# Work Order ID 101353

Item Name: Crosstube Turning DetailL

| <b>Description:</b> Crosstube Assembly (206L High Fwd) |  | <b>Part Number:</b> D206-667-143 |

| DRAWING NO.<br>D206-667-143 | TITLE<br>CROSSTUBE ASS'Y (206L HIGH FWD) | REV. C                    | DART AEROSPACE LTD<br>ENGINEERING ORDER |  | D.E.O. NO.<br>D206-667-143-C-1 | SHEET NO.<br>SHEET 1 OF 1 | SCALE<br>NTS |

| DRAWING NO.<br>D206-667-143 | TITLE<br>CROSSTUBE ASS'Y (206L HIGH FWD) | REV. C                 | DART AEROSPACE LTD<br>ENGINEERING ORDER |                       | D.E.O. NO.<br>D206-667-143-C-2 | SHEET NO.<br>SHEET 1 OF 1 | SCALE<br>NTS |

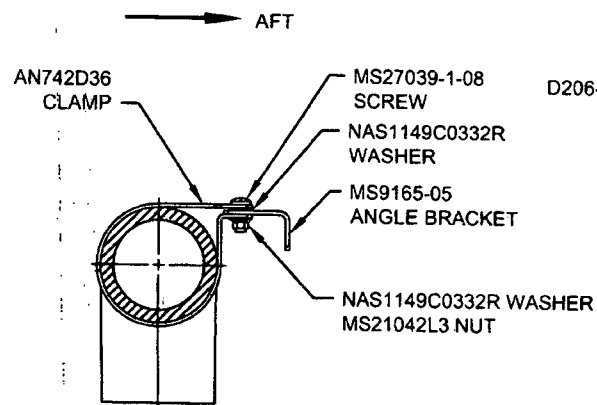
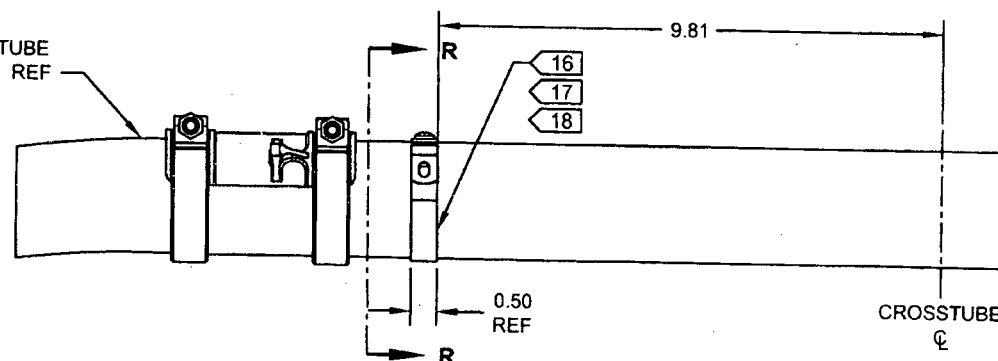
ADD ELECTRICAL GROUNDING STRAP

**SECTION R-R**

**DETAIL P**  
 BONDING STRAP INSTALLATION 2 PL
